August 27, 2021

Re: **Sunoco Pipeline LP – Pennsylvania Pipeline Project (Mariner East II)**  
**Chapter 105 Permit No. E15-862**  
**Major Amendment – HDD S3-0290**  
**Response to Technical Deficiency Comments**  
**Upper Uwchlan Township, Chester County, PA**

In an August 6, 2021 letter from the Department, Sunoco Pipeline, LP (“SPLP”) received technical deficiency comments regarding review of Chapter 105 Major Amendment Request which was submitted to the Department on April 7, 2021 and determined to be complete by the Department on April 16<sup>th</sup> for the 290 HDD location in Upper Uwchlan Township, Chester County (the “290 HDD”). That request of the Department was for a change in the crossing method at Wetland H17 and its associated tributaries from an HDD to an open trench.

**Figure 4.**  
**Existing Utilities in Vicinity of**  
**Options 3, 4, and 5**

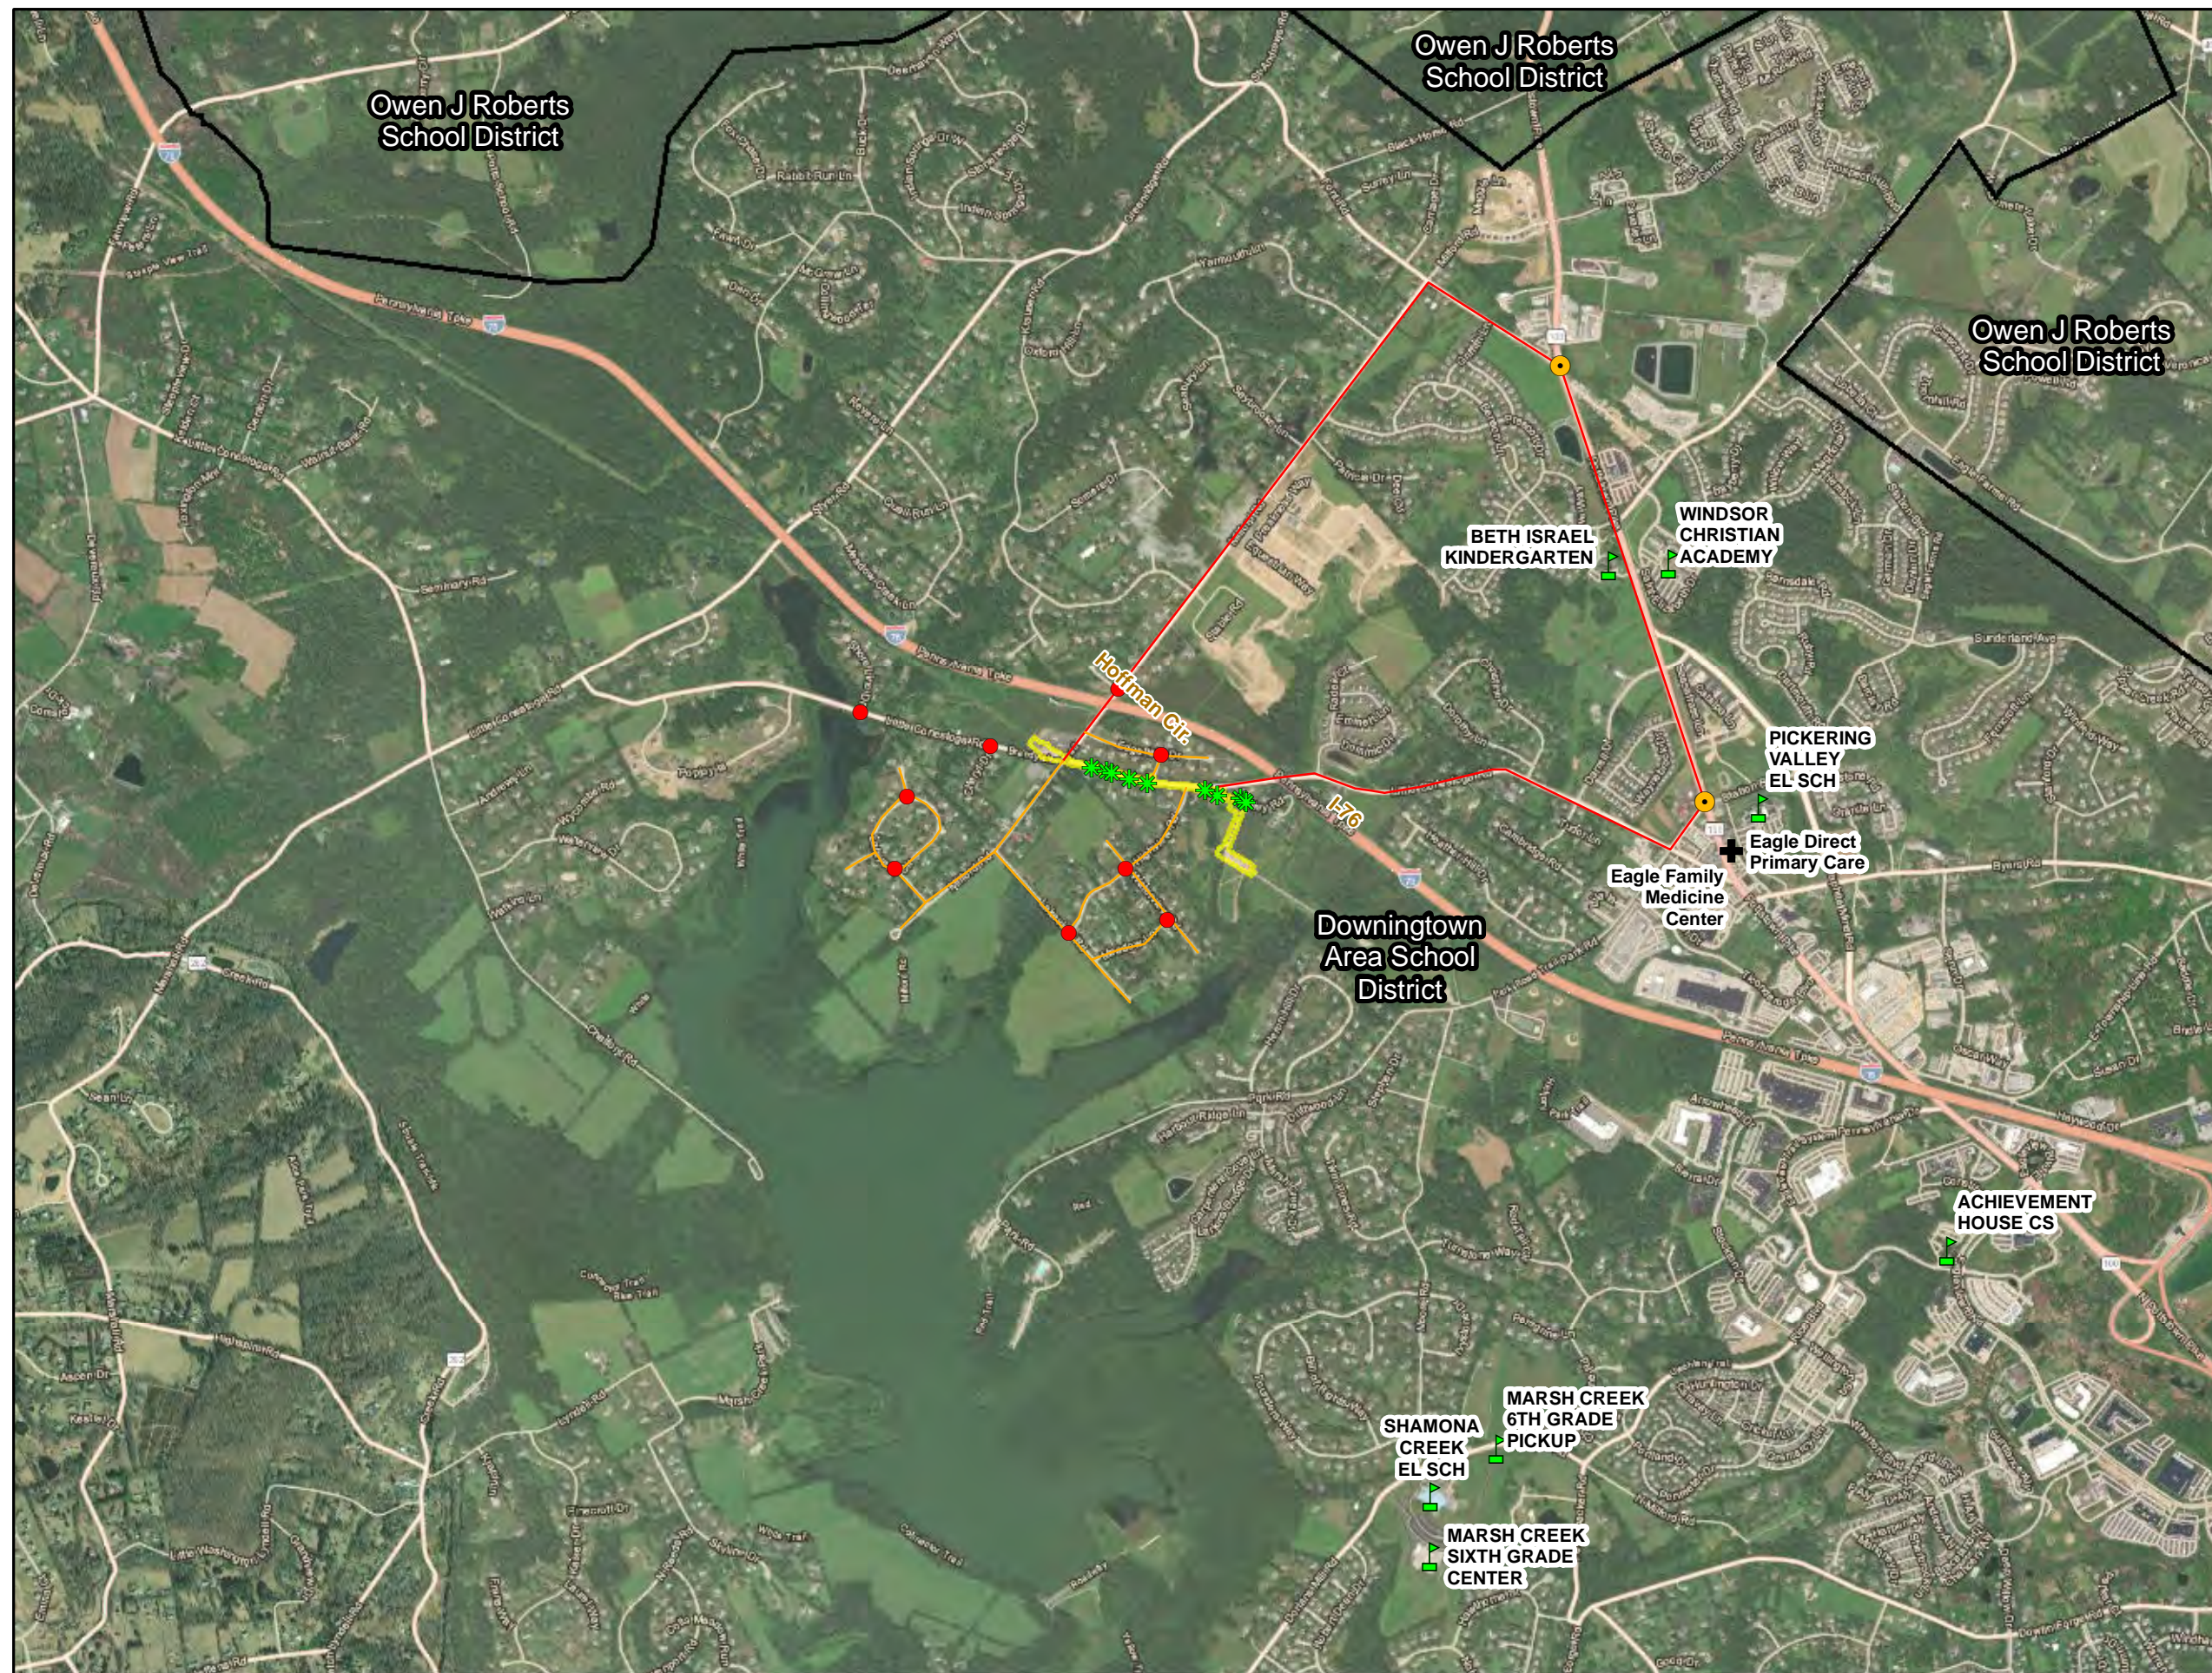
- k) Identify water mains, wells or other associated structures that are in the proposed route. If public water supply wells are within 1,000 ft provide documentation that the water supplier was notified and that they do not object to the project.

In response to TD comments 1(c) and 1(k), these utility locations (including public and private water supplies, wells, and pipelines) in the vicinity of Options 3, 4, and 5 are mapped and presented in **Figure 4 (Appendix C)**. Based on the results of the mapping and assessment of utility data, numerous individual utilities would be paralleled or crossed by the pipeline centerline or construction workspace for Options 3, 4, and 5, particularly at the open cut construction method crossing of the intersection of Milford Road/Little Conestoga Road. Based on assessment of these results, the utility data do not provide a meaningful or material factor that discerns between impacts associated with the options (and for this reason, certain utility data are not included in **Table 3**), except in individual cases as presented in this analysis.
